T10/07-361r2

To	From	Subject	Date
INCITS T10 Committee	Curtis Ballard, HP Michael Banther, HP	SSC-3 Out of Band Encryption Key Management	10 October, 2007

Figure 8 — UML example of SCSI target device and physical device

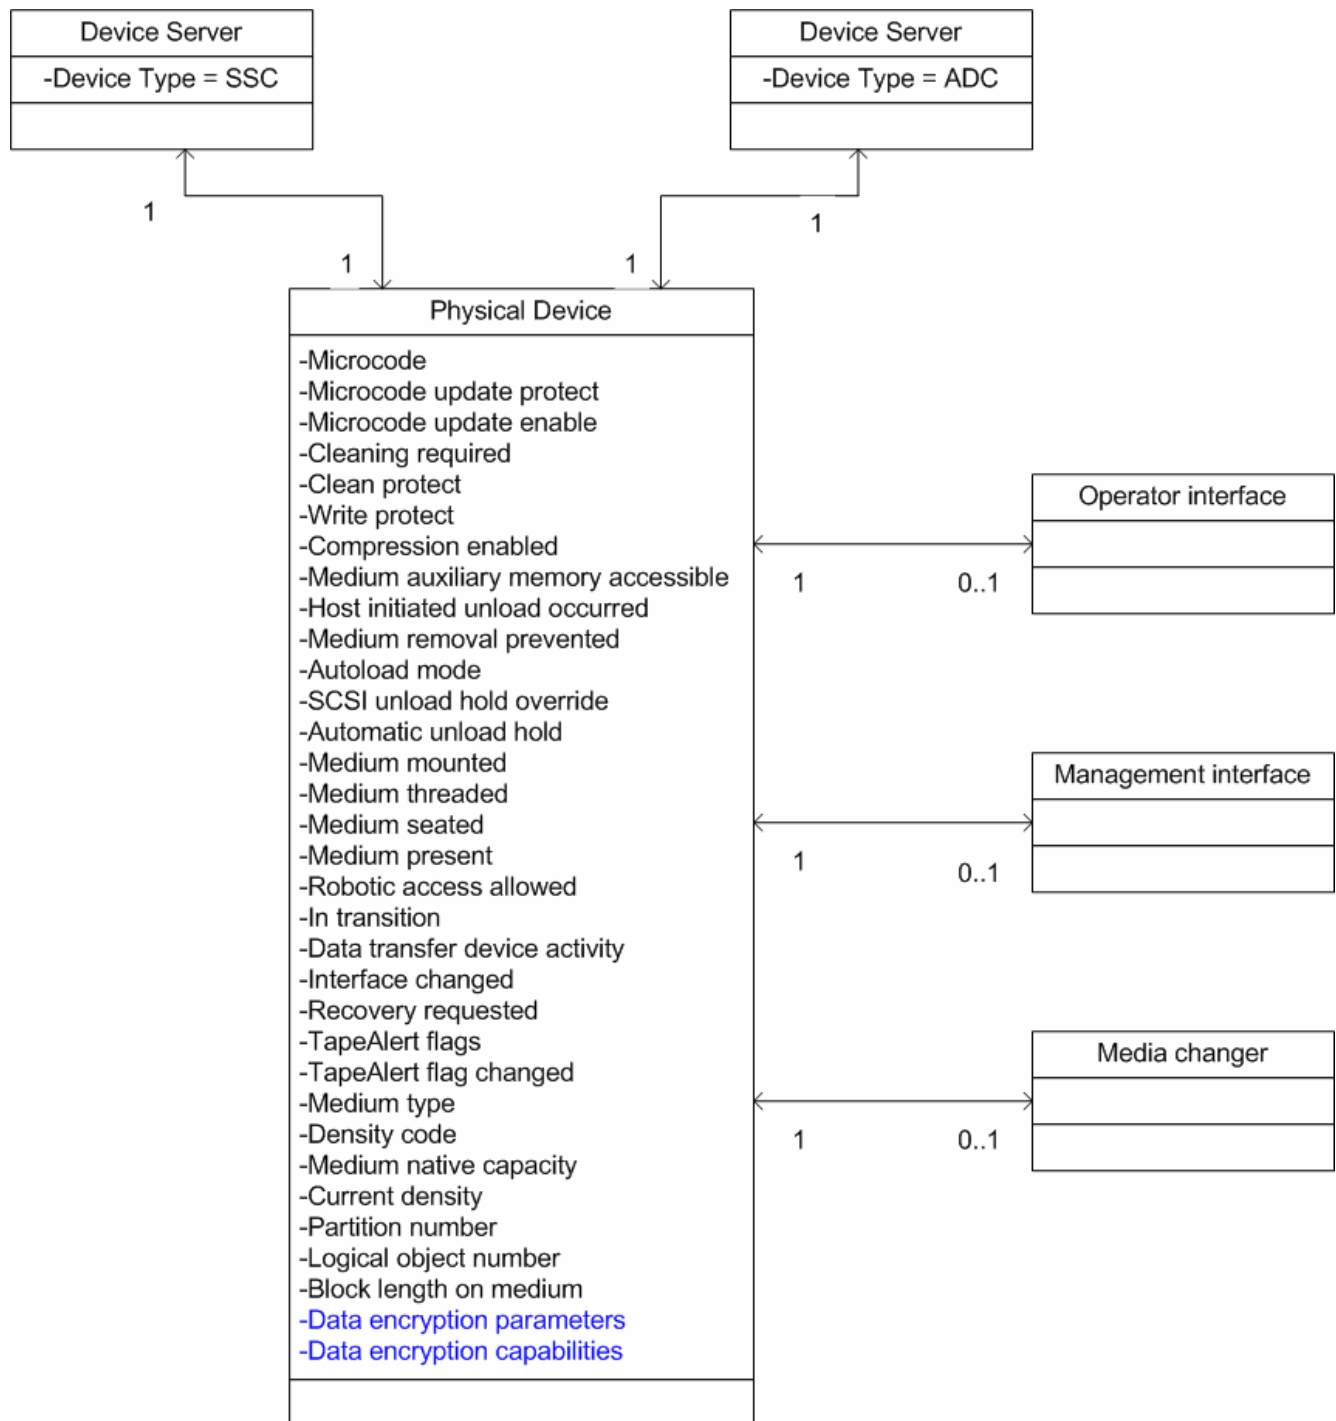
Add data encryption parameters and data encryption capabilities to list of items in physical device in figure 8.
